# PERMIT

SEWAGE DISPOSAL SYSTEM

HOWARD COUNTY  
BUREAU OF ENVIRONMENTAL HEALTH  
992-2330

SUBDIVISION Formerly Travers Prop. ROAD 11475 Route 216 LOT \_\_\_\_\_

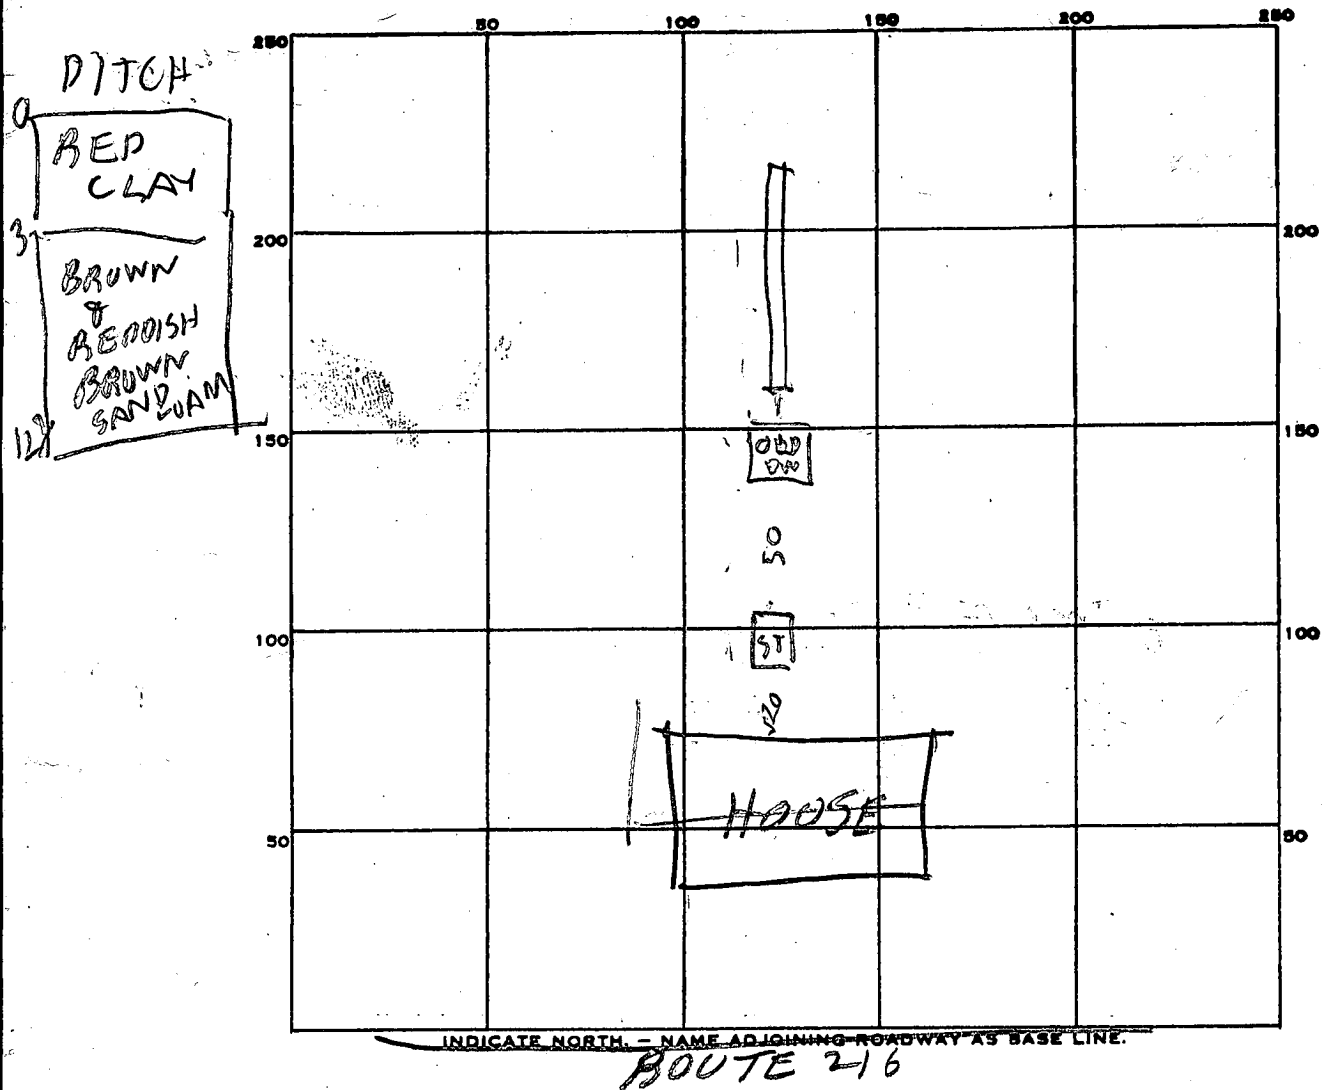
REPAIR - CALL FOR INSPECTION WHEN FROUND IS OPENED UP SO SANITARIAN CAN RECOMMEND

REPAIR. OBSERVED GROUND

4/13/84 DEEP DITCH 12FT DEEP 2 FT WIDE 8FT  
STONE 80 FT LONG WITH INLET TO DITCH  
3-4 FT DEEP RUN DITCH OFF  
OLD DRY WELL IN BACK YARD  
TOWARD BACK OF LOT BH

REMARKS 4/13/84 130 SOIL OK DECIDED DEEP DITCH REPAIR  
4/13/84 250 PM DITCH LENGTHENED TO 71 FT  
EXTEND DITCH TO 80 FT ADD STONES CALL  
4/16/84 1105 AM - DITCH EXTENDED TO 83 FT &  
STONE ADDED RH

DATE SYSTEM APPROVED 4/16/84 INSPECTOR Raymond Hodges
